Appendix G: Public and Agency Comments

TECHNICAL MEMORANDUM

Summary of Public and Agency Scoping Comments
Town of Fuquay-Varina Water Supply and Interbasin Transfer Project

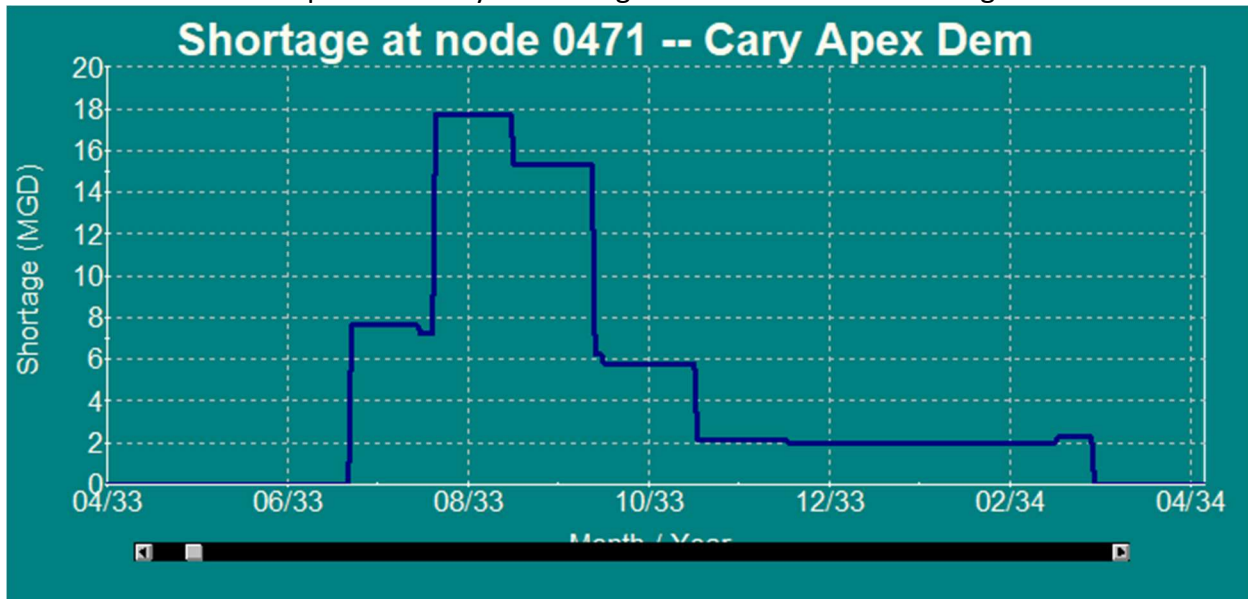
- Summary Table for Shortage Calculations:
 - The alternatives are simulated with drought plan on. However, the shortages shown in the table are calculated without drought plan. With drought plan, the systems without WSRP would show their regular shortages or no shortages anyway. Valid shortages in few systems [like Cary] shown in Table 3, Appendix C might create more questions.
 - Adding two more columns might give a different perspective of the shortage periods as is done for the climate change in Appendix C - Table 8
 - Longest duration (in days) of the shortage period.
 - No. of years impacted.

- Frequencies/stages of drought triggered.

Example here: Cary is showing almost 8 months of shortages

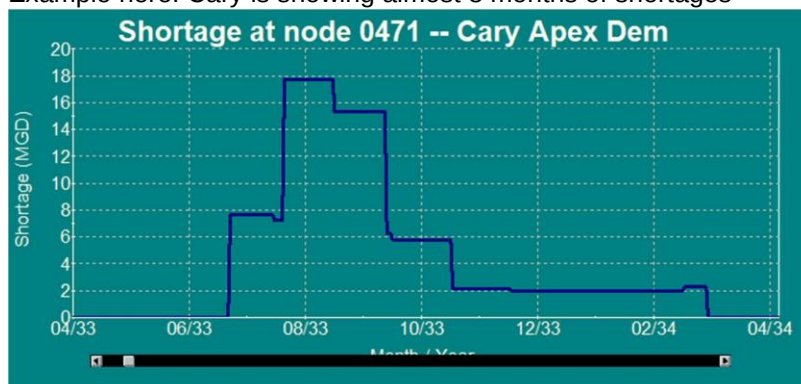
- Summary Table for Shortage Calculations:
 - The alternatives are simulated with drought plan on. However, the shortages shown in the table are calculated without drought plan. With drought plan, the systems without WSRP would show their regular shortages or no shortages anyway. Valid shortages in few systems [like Cary] shown in Table 3, Appendix C might create more questions.

Hazen has tried to clarify this rather complicated situation by adding Tables 4a and 4b to the Appendix C: Technical Memorandum for OASIS Hydrologic Model of Cape Fear and Neuse River Basins for Interbasin Transfer
